Point Beach Nuclear Plant, Units 1 and 2
Dockets 50-266 and 50-301
Renewed License Nos. DPR-24 and DPR-27

License Amendment Request 261
Extended Power Uprate
Response to Request for Additional Information

NEXTERA ENERGY POINT BEACH, LLC POINT BEACH NUCLEAR PLANT, UNITS 1 AND 2

LICENSE AMENDMENT REQUEST 261 EXTENDED POWER UPRATE RESPONSE TO REQUEST FOR ADDITIONAL INFORMATION

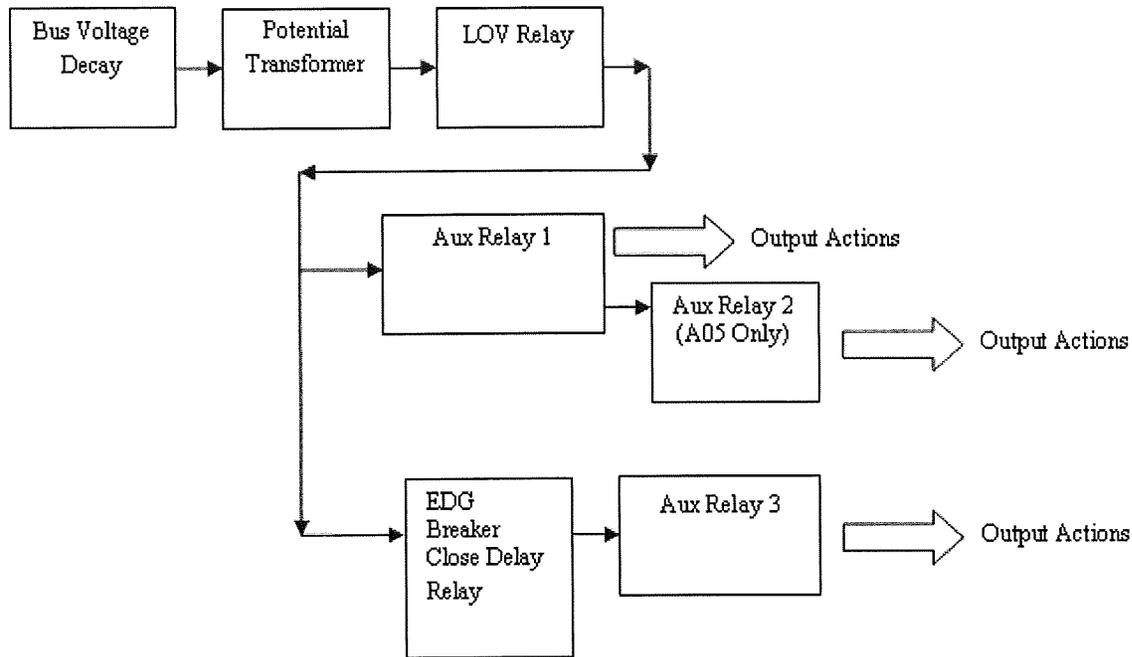
The following statement applies to request for additional information (RAI) EEEB-1 through 4:

The proposed change would extend the time delay of the loss of voltage (LOV) relay to 2.3 seconds when it actuates at approximately 3156V. The proposed change also extends the closure time for emergency diesel generator (EDG) breaker to 3.55 seconds. The degraded voltage (DV) relay is set at approximately 3937V with a time delay of 5.68 seconds with a concurrent safety injection signal (SIS) and 39.14 seconds without a SIS available. The DV protection scheme does not directly start the EDG. A trip of the DV relay actuates the LOV relay which adds 2.3 seconds for relay actuation and 3.55 seconds for breaker closure, to the total time for start of EDG.

The degraded voltage (DV) Technical Specifications (TS) allowable values are based on the maximum safety limit (SL) of 6 seconds with a safety injection (SI) signal present and a maximum SL of 48 seconds without a SI signal present. The bus DV relay and the bus time delay relay provide the time delay for the DV scheme. For additional details on the DV TS, see Reference (3).

Additional clarification on the operation of the loss of voltage (LOV) relays and the emergency diesel generator (EDG) breaker close delay relays is presented below in the block diagram which illustrates the logic scheme:

In this scheme, auxiliary relay 1 (A05 and A06 bus) and auxiliary relay 2 (A05 bus only) provide the trip to the incoming 4.16 kV feeder breaker to A05/A06 and provide a start signal to the EDGs associated with the bus. Auxiliary relay 3 provides a close permissive for the EDG output breaker. Both the permissive from auxiliary relay 3 and the EDG ready to load permissive (adequate EDG voltage and speed) must be made up for the EDG output breaker to close.

The voltage and time delay settings for the relays in the 4.16 kV LOV scheme were selected in conjunction with the voltage and time delay settings for the 480 V LOV scheme whether the EDGs are running or not to ensure the following:

1. The EDGs will be started and their output breakers can be closed onto the bus within 14 seconds or less.
2. The EDGs will be able to meet the 14 seconds requirement for output breaker closure when considering a loss-of-coolant accident (LOCA) coincident with a DV condition.
3. 4.16 kV loads are stripped prior to closing the EDG output breakers to prevent block loading the 4.16 kV loads and to allow proper sequencing of loads.
4. The 480 V loads are stripped prior to closing the EDG output breakers to prevent block loading the 480 V loads and allow proper sequencing of the loads.
5. The motor voltage for both 4.16 kV and 480 V motor loads has decayed to a safe level prior to re-energizing buses to prevent damage to the motors resulting from being energized out of synchronization with the incoming EDG voltage.

Based upon the above requirements, the LOV relays and EDG breaker close delay relay requirements were established and provide basis for the TS change to Surveillance Requirement (SR) 3.3.4.3 previously submitted in Reference (2).

The LOV TS allowable values provided in LAR 261 are based on the minimum SL of 1.5 seconds and a maximum SL of 3 seconds. The minimum SL establishes the minimum time delay required to prevent premature separation from offsite power during a transmission system transient. The minimum time delay was selected based on transmission studies performed in accordance with North American Electrical Reliability Corporation (NERC) guidelines and the plant's licensing basis to ensure PBNP would remain connected to offsite power for a transmission system transient to allow protective relays on the transmission system to clear the transient and not separate from offsite power. The maximum SL was established to ensure that after a LOV event, the EDG would supply the safety-related buses within the requirements of the safety analysis.

The total maximum time for the EDGs to start and energize the bus is the sum of the bus voltage decay (0.8 sec), LOV relay time delay (safety limit value of 3 sec), auxiliary relay (0.1 sec), EDG start delay (10 sec) and EDG circuit breaker close delay (0.1 sec). These time delay values support the maximum 14-second requirement to re-energize the 4.16 kV buses to support Final Safety Analysis Report (FSAR) Chapter 14 accident analyses.

The EDG breaker close delay TS allowable values provided in LAR 261 are based on a minimum SL of 1.8 seconds and a maximum SL of 4 seconds. The minimum SL establishes the minimum time delay required to allow operation of the 480 V LOV relays to actuate and initiate load stripping and to allow sufficient time for the system voltage to decay to a safe level prior to re-energizing the safety-related buses by the EDG to prevent equipment damage. The maximum SL was established to ensure that after a DV or a LOV event, the EDG would supply the safety-related buses within the requirements of the PBNP safety analysis.

The worst-case condition for the EDG breaker close delay relay is when a LOV is preceded by a DV condition coincident with a SI signal. Therefore, the total time for the safety-related buses to be energized by the EDG is the sum of bus DV relay (safety limit of 6 seconds), bus voltage decay (0.8 sec), LOV relay time delay (safety limit value of 3.0 sec), auxiliary relay (0.1 sec), EDG breaker close delay relay (safety limit of 4 seconds) and EDG circuit breaker close delay (0.1 sec). These time delay values provide the basis for the maximum 14 second requirement to support FSAR Chapter 14 accident analyses. This bounds the condition for a LOV condition which would result in a maximum start time of 10 seconds for the EDG circuit breaker close delay because the timer operates at the same time as the EDG start.

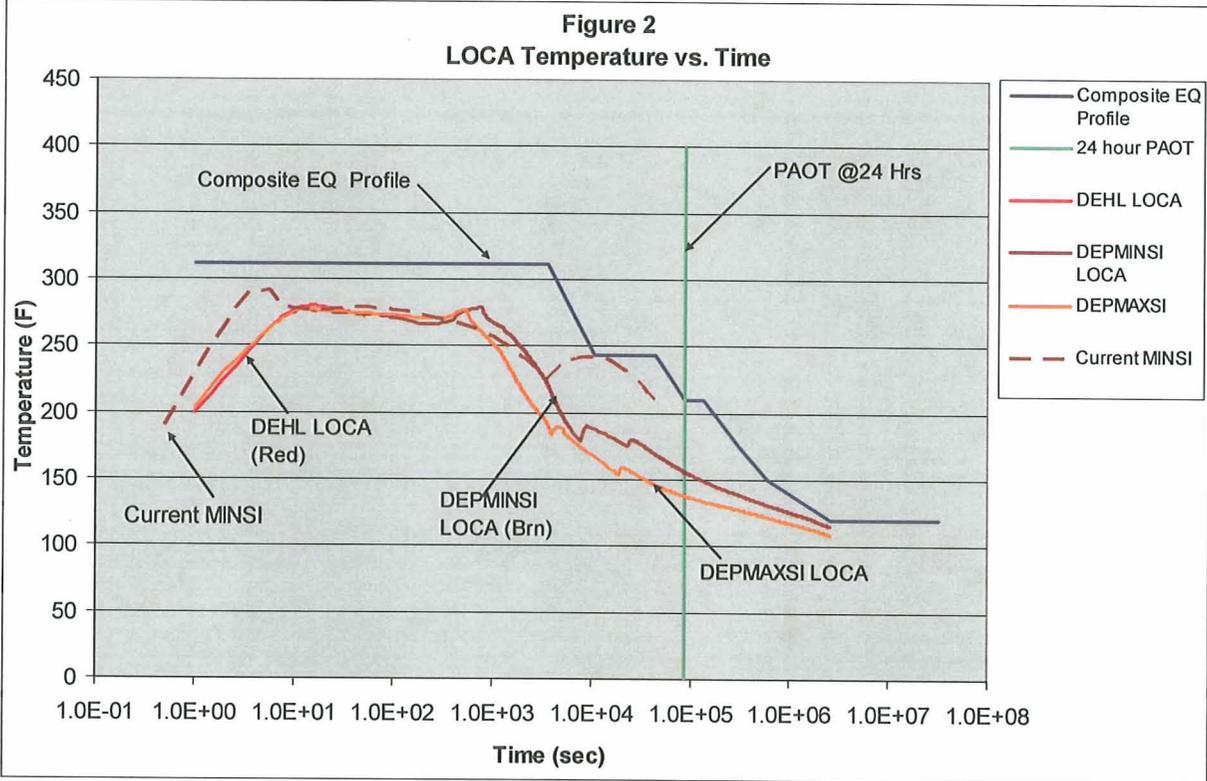
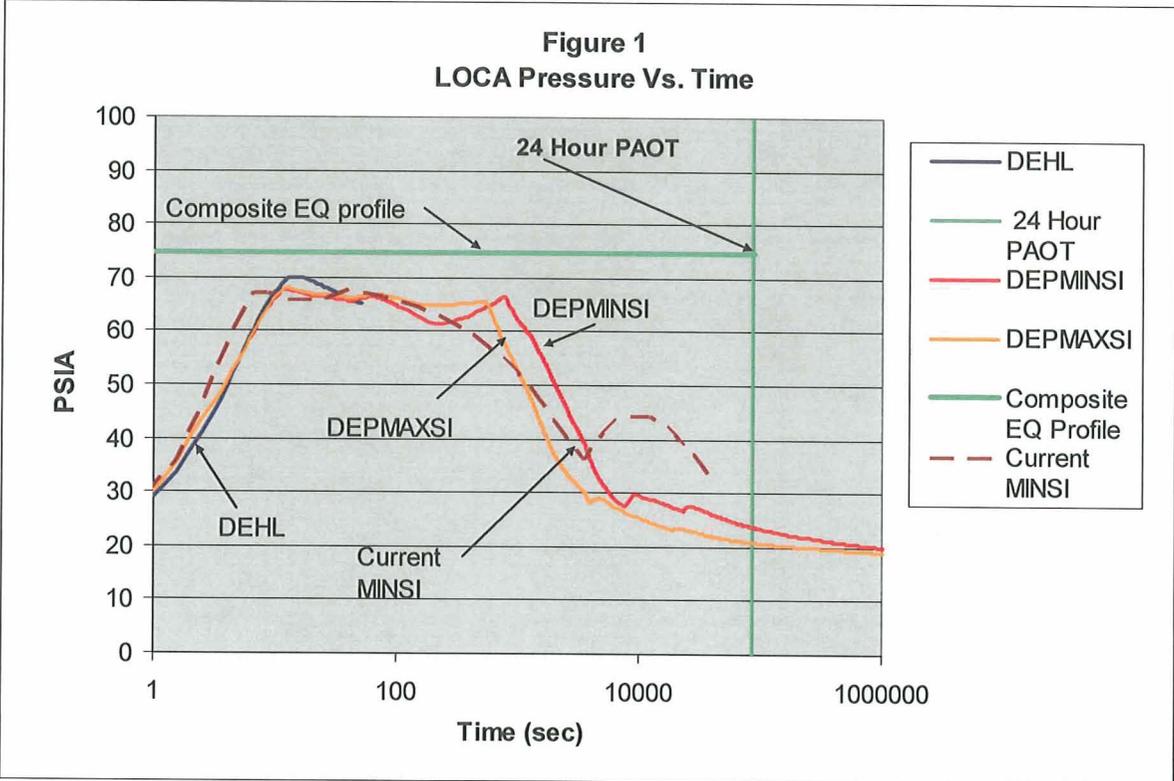
EEEE-5

The NRC staff requests the licensee to provide a detailed comparison of the following EQ temperature and pressure profiles:

- a. *Current conditions*
- b. *Existing bounding EQ profile*
- c. *At proposed EPU conditions*

LAR 261, Attachment 5, Section 2.3.1, Environmental Qualification of Electrical Equipment, Tables 2.3.1-1 through 2.3.1-4 provides a comparison of the current environmental qualification (EQ) parameters and EPU EQ parameters. Figures 2.3.1-1 and 2.3.1-2 provide a comparison of the containment LOCA EPU temperature and pressure profiles to the composite EQ profiles. Using these figures, an additional curve of the current LOCA minimum SI (MINSI) containment pressure and temperature response are provided in Figures 1 and 2.
